REFERENCE:  
BULLETIN 54-48

## SERVICE BULLETIN CHANGE NOTIFICATION

SUBJECT: NACELLES/PYLONS - Attach Fittings - Replace Engines 1 And 3 Wing Pylon  
Aft Attach Spherical Bearings.

MODEL: DC-10, Series 10, 30, and 40.

FIGURE 1

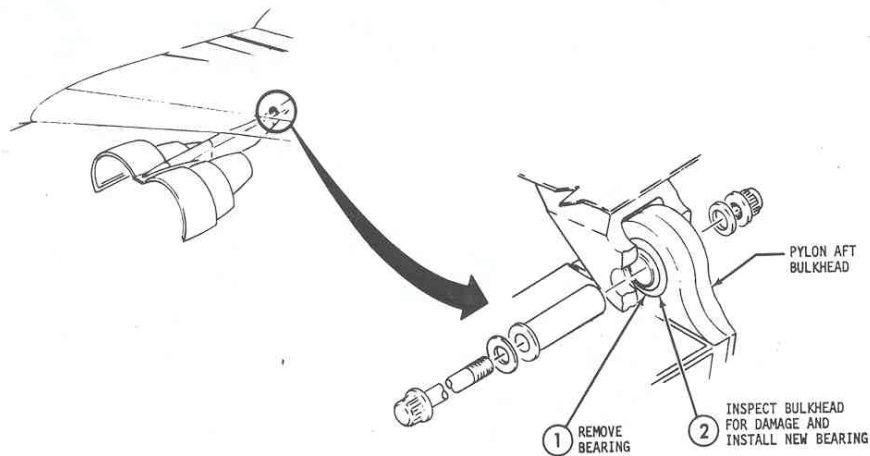
Page 8: Revised Step 2 to add additional oversize bearing and tooling information.

Changed wing pylon aft bearing oversize hole tool set tool number to DZZ7244-1 "C", was DZZ7244-1 and added detail parts to kit.

- ① REMOVE KSBY22N1, ATBY22V4, BLFR22-034, YTA301, 76689, LHSS22-77, LHSSR22-77, OR KSBY22-2 BEARING USING DZZ7237-1 WING PYLON AFT BEARING REMOVAL SET TOOLS AND HP-60G ENERPAC PUMP AND CYLINDER SET. (SEE MAINTENANCE MANUAL CHAPTER 54-00-00, PARAGRAPH ENTITLED "REMOVE PYLON", STEP 43b.)

- ② VISUALLY INSPECT BULKHEAD FOR EVIDENCE OF DAMAGE DUE TO GOUGING OF BEARING INTO BULKHEAD AND ACCOMPLISH THE FOLLOWING:

- a. IF DAMAGE IS NOT EVIDENT, MEASURE HOLE IN BULKHEAD. IF HOLE SIZE IS 2.9985/2.9990(76.1619/76.1746)-INCH DIAMETER INSTALL NEW KSBY22-5, BSSR-22220, NSS22D, OR 79583 BEARING USING DZZ7237-1 WING PYLON AFT BEARING TOOLS AND HP-60G ENERPAC PUMP AND CYLINDER SET. (SEE MAINTENANCE MANUAL CHAPTER 54-00-00, PARAGRAPH ENTITLED "REMOVE PYLON", STEP 43c.)

NOTE: IF HOLE SIZE IS GREATER THAN 2.9990(76.1746)-INCH DIAMETER, OVERSIZE BEARING MUST BE INSTALLED PER STEP 2b.

- b. IF DAMAGE IS EVIDENT OR HOLE SIZE EXCEEDS 2.9990(76.1746)-INCH DIAMETER, ENLARGE HOLE IN BULKHEAD IN INCREMENTS NOTED AS REQUIRED TO CLEANUP DAMAGE, CHAMFER BOTH HOLE EDGES .045+.010(1.143+.254) X 45° USING APPLICABLE REAMER AND CUTTER FROM DZZ7244-1 "C" TOOL SET. SEE TABLE 1. (SEE MAINTENANCE MANUAL CHAPTER 54-00-00, PARAGRAPH ENTITLED "REMOVE PYLON.")

FINAL HOLE SIZE	REAMER	CUTTER	APPLICABLE BEARING
3.0005/3.0010 (76.2127/76.2254)	DZZ7244-29	DZZ7244-35	KMS1005 (.002(.0508)-INCH OVERSIZE)
3.0085/3.0090 (76.4159/76.4286)	DZZ7244-31	DZZ7244-37	KMS1006 (.010(.2540)-INCH OVERSIZE)
3.0185/3.0190 (76.6699/76.6826)	DZZ7244-33	DZZ7244-39	KMS1007 (.020(.5080)-INCH OVERSIZE)
3.0285/3.0290 (76.9239/76.9366)	DZZ7244-3	DZZ7244-5	KMS705 (.030(.7626)-INCH OVERSIZE)
			OR
			LH22F
			OR
			79828

NOTE: OVERSIZE BEARING TO BE USED ONLY WHEN DAMAGE IS EVIDENT OR HOLE IN BULKHEAD EXCEEDS 2.9990(76.1746)-INCH DIAMETER.
